Date: Wednesday 28 - Friday 30 July 2021
Monday 2 - Thursday 5 August 2021
Time: 9.30am
Meeting room: Manukau room
Venue: Level, Civic Building
31-33 Manukau Station Road, Manukau

PRIVATE PLAN MODIFICATION 48
HEARING REPORT – VOLUME ONE
DRURY CENTRE PRECINCT
KIWI PROPERTY NO.2 LIMITED

Figure 9: Open space recommended locations

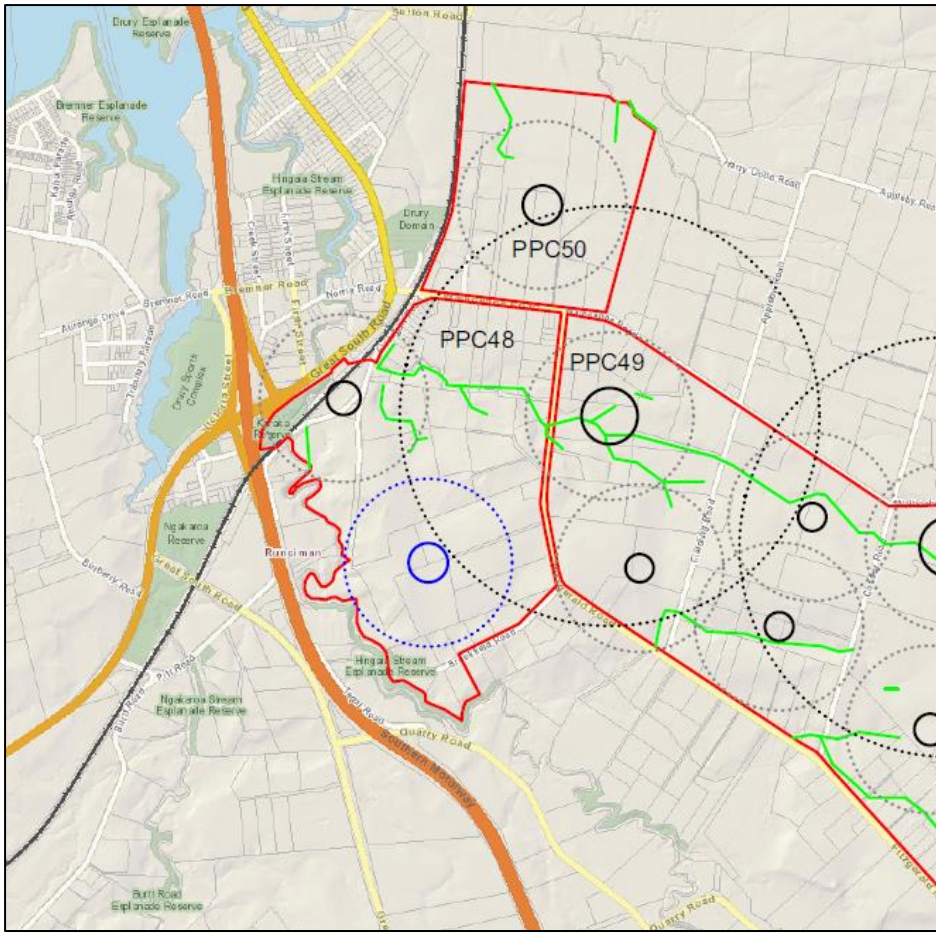
246. Ms Richards states that the indicative locations of open spaces need to be shown spatially on a precinct plan. She recommends that two indicative neighbourhood reserves of 3,000-5,000m² are shown on a Precinct Plan, as illustrated on Figure 9 below. One of these (Station Plaza) is as proposed by the requestor, and already shown on Precinct Plan 2, but the proposed location of Homestead Park is not supported as it is not far south enough to meet Council's open space acquisition criteria and serve the plan change catchment. An alternative location for a neighbourhood reserve is recommended in blue on Figure 9.

Figure 10: Recommended greenways to be shown on precinct plan

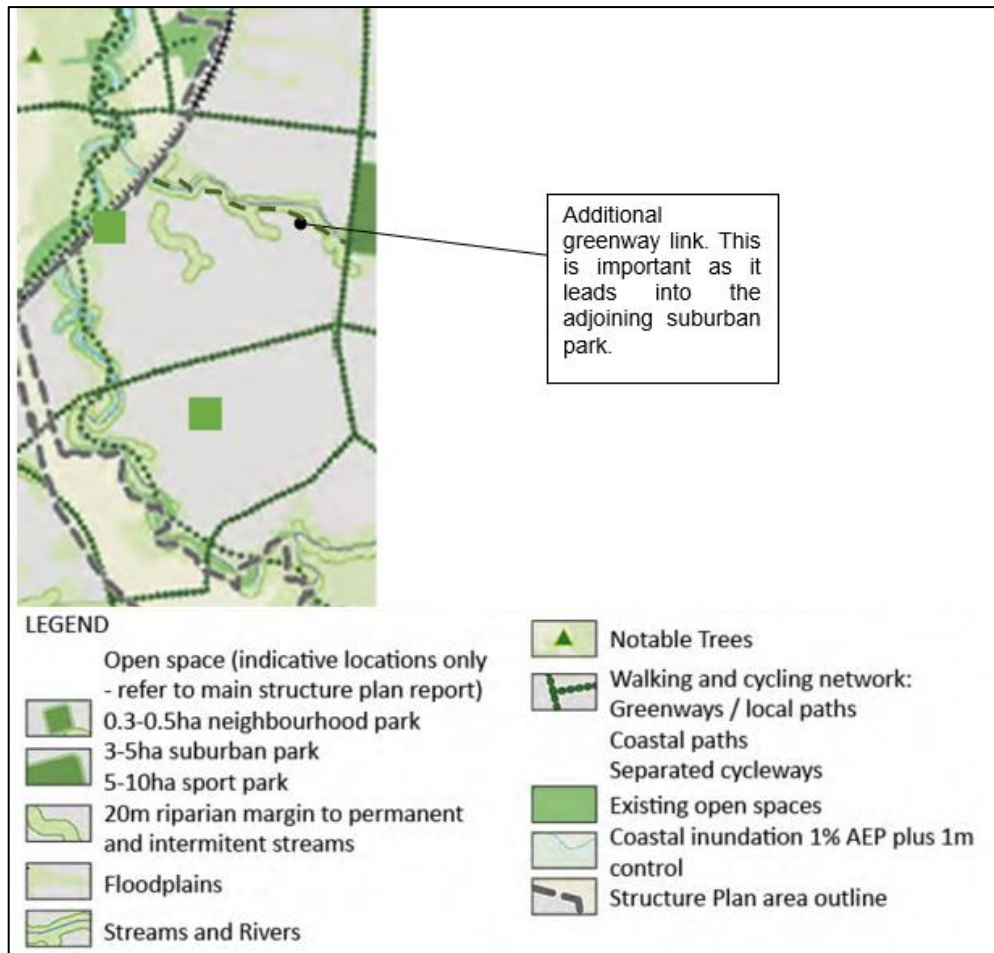
247. Ms Richards also assesses that the plan change does not provide a clear network of walkways within the proposed open space and riparian reserve network. In her experience, relying on the AUP subdivision provisions in Chapter E38 is insufficient to ensure the outcomes sought around greenways are secured, and maintenance and enhancement of permanent and intermittent streams is more likely to be achieved if these are shown indicatively on precinct plans. She therefore recommends that the indicative locations of wetlands and streams to be retained, riparian areas to be enhanced and indicative greenway routes (walkways/cycleways) are shown on the precinct plan as shown on Figure 10 below. The confirmed locations of the wetlands and streams can be identified through future consent applications, and Ms Richards recommends a special information requirement to this effect.

254. I recommend in section 8.8 below that streams are shown on a precinct plan in relation to ecological effects. I agree that greenways along stream corridors need to be shown on the precinct plan to better secure these being delivered through future subdivision and to give effect to RPS Policy B2.7.2(2) - promoting the physical connection of open spaces. This will not prevent the adjustment of the locations through the development process once further detailed planning and stream surveys are completed. I support amendments to the precinct provisions to specify required locations of walkways/cycleways within these corridors in relating to riparian planting.¹³

Figure 12: Future Train Station

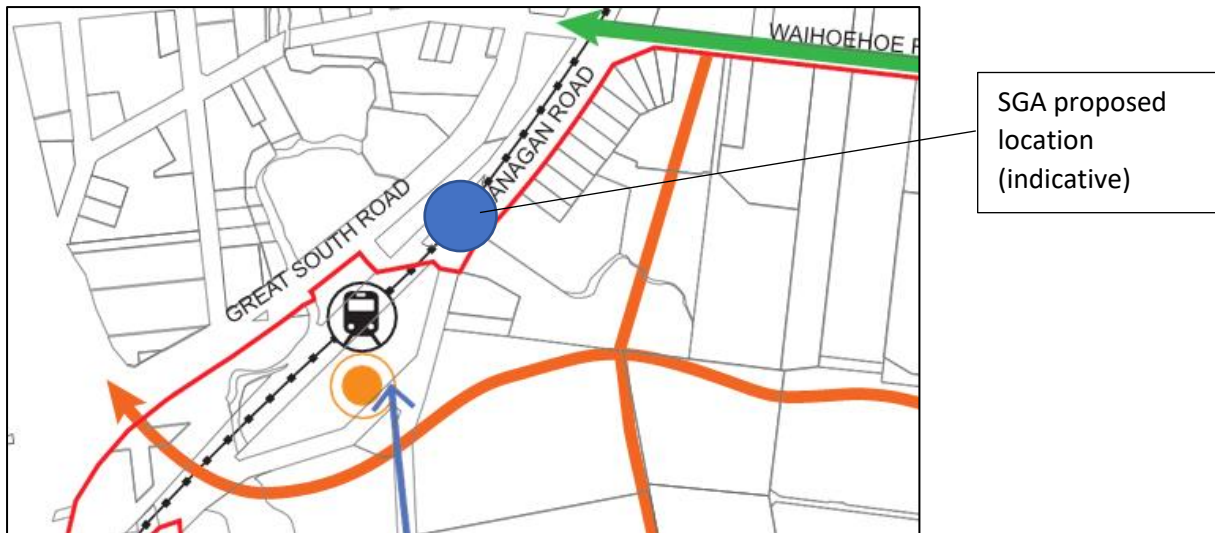
557. I agree with the submitters that the station location should be amended. SGA has published a preferred station location somewhat further to the north than that shown by the notified Precinct Plan (see Figure 12). Associated with the station is the proposal for a 'station plaza'. The notified plan change describes that a public plaza is provided for that will integrate the train station with the centre and will provide a high quality pedestrian experience. With the shift of the train station, the form of this plaza and who will deliver it will need to be determined.

Fig 3. Open space supported by Parks, Sport and Recreation with PPC49 and 50 for context. Small circles identify neighbourhood parks and large circles identify suburb parks. Blue circle identifies approximate location of supported neighbourhood park.

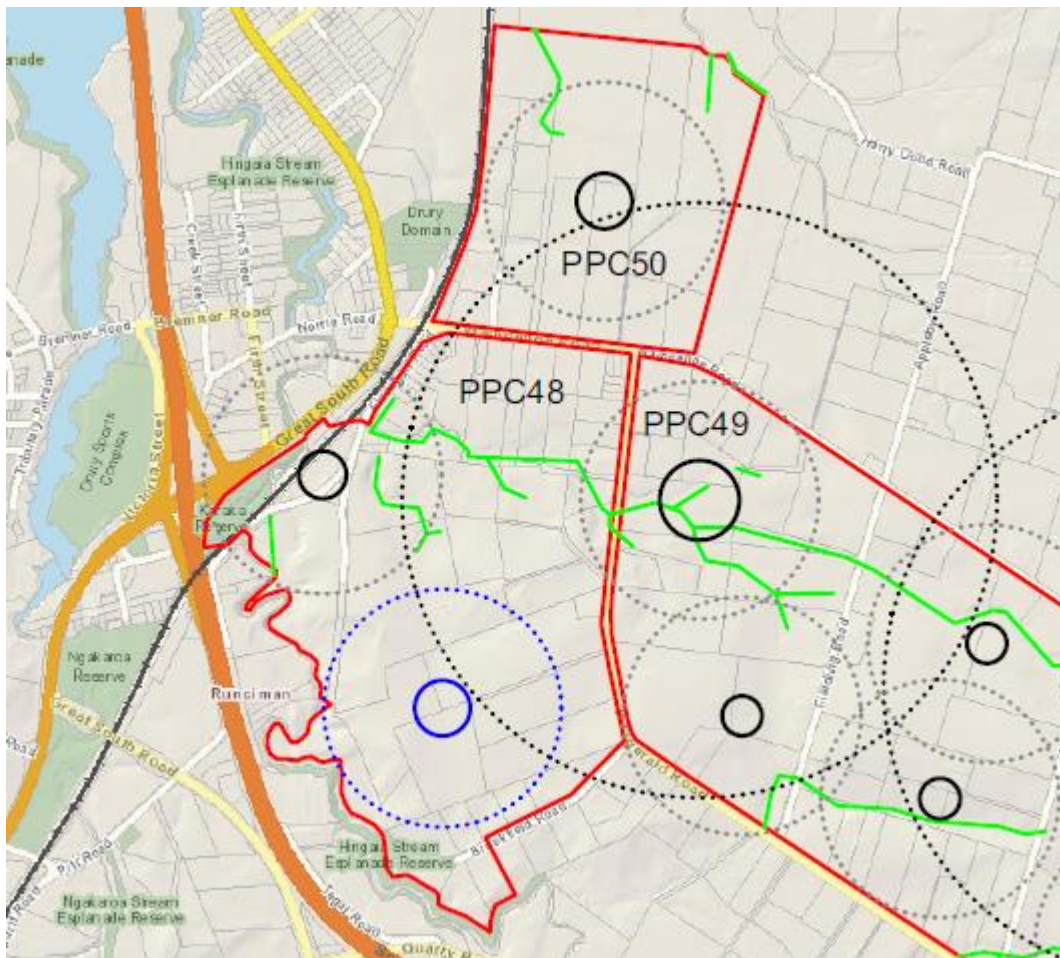
- 2.9 Both figure 1 and figure 2 result in an under provision of open space access for a large portion of the PC48 area. Open space shown on Drury-Opāheke Structure Plan maps is indicative only, although it is based on Auckland Council open space policy. Exact alignment with the structure plan is not considered essential by the Council due to the changing nature of the regulatory environment, such as the NPS-UD. However, alignment with open space policy is still considered paramount. The placement of Homestead Park, fixed due to the location of the Homestead, is not supportable as it does not meet Council's open space acquisition criteria. It is recommended this is located further south within the plan change site as shown in figure 3 below:

Drury Centre Precinct Plan 2 - Spatial features

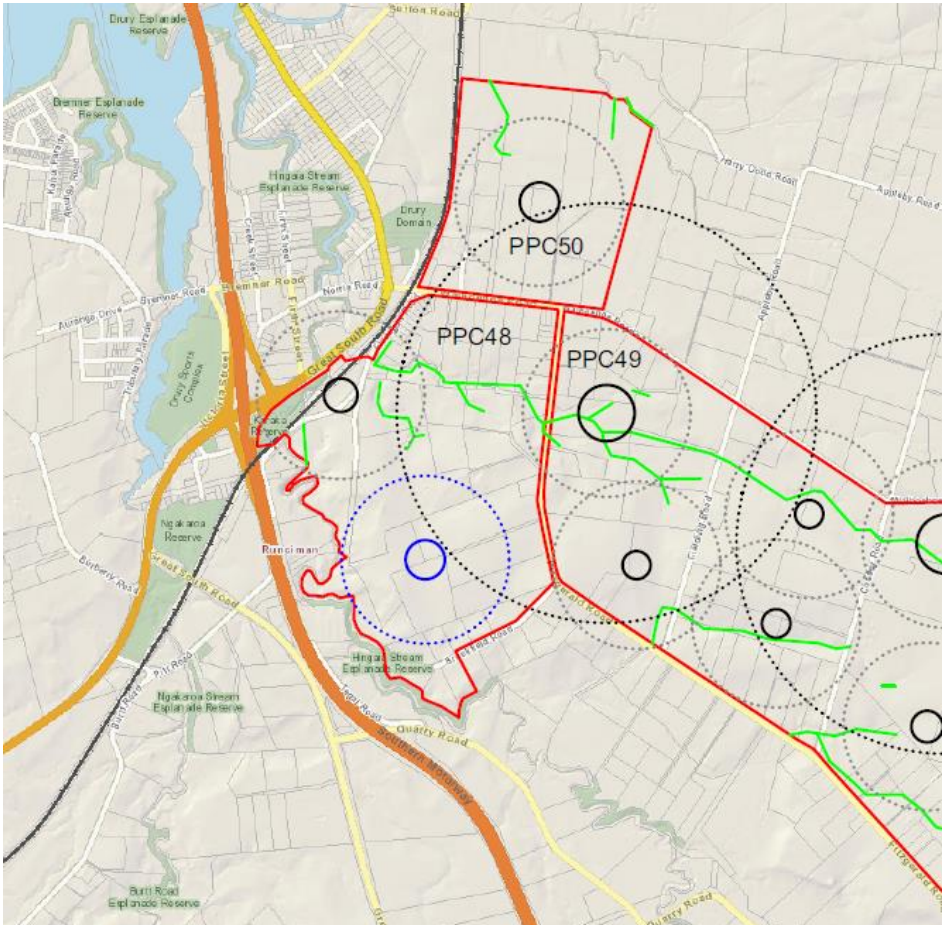
<p>The precinct plans do not identify permanent and intermittent streams, greenways or indicative open space.</p> <p>The below map of 'indicative open space' should be included in the precinct plan for PC48 and open space should be recorded as such in the legend.</p>  <p>The below map of 'indicative greenways' should be included in the precinct plan and greenways should be recorded as such in the legend.</p>
--	--
